CALVERT CLIFFS
NUCLEAR POWER PLANT

SUBJECT: Calvert Cliffs Nuclear Power Plant
Independent Spent Fuel Storage Installation; Docket No. 72-8
License Amendment Request: High Burnup NUHOMS®-32PHB Dry Shielded
Canister

EVALUATION OF THE PROPOSED CHANGE

Figure 4 – NUHOMS®-32PHB DSC Maximum Heat Load Zone Configuration

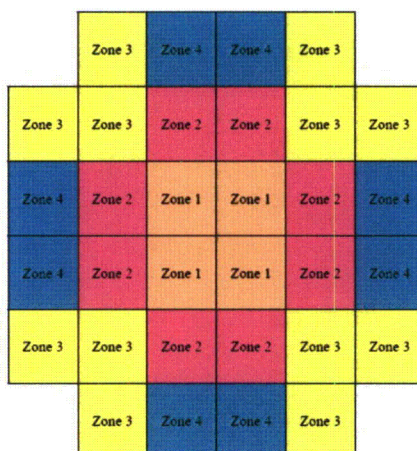
The current maximum heat generation rate limit is 0.66 kW per fuel assembly for the NUHOMS®-24P and NUHOMS®-32P DSCs. The proposed amendment would add a new maximum heat generation rate of 0.8 kW per fuel assembly for NUHOMS®-32PHB DSC basket zones 1 and 4, and a maximum heat generation rate of 1.0 kW per fuel assembly for NUHOMS®-32PHB DSC basket zones 2 and 3 (see Figure 4). Zoning is used in combination with time limits on certain loading operations to accommodate the maximum total NUHOMS®-32PHB DSC heat loads up to 29.6 kW while maintaining fuel cladding and DSC component temperatures below their respective design limits. NUHOMS®-32PHB DSCs with total heat loads of 25.6 kW (limit of 0.8 kW per fuel assembly for all zones) or 23.04 kW (limit of 0.72 kW per fuel assembly for all zones) may utilize longer time limits as discussed below. Appropriate discharge cooling times have been determined for fuel assemblies to be loaded into a NUHOMS®-32PHB DSC and will be added to USAR Table 9.4.1. The current maximum heat generation rate for the NUHOMS®-24P and NUHOMS®-32P DSCs remain the same.
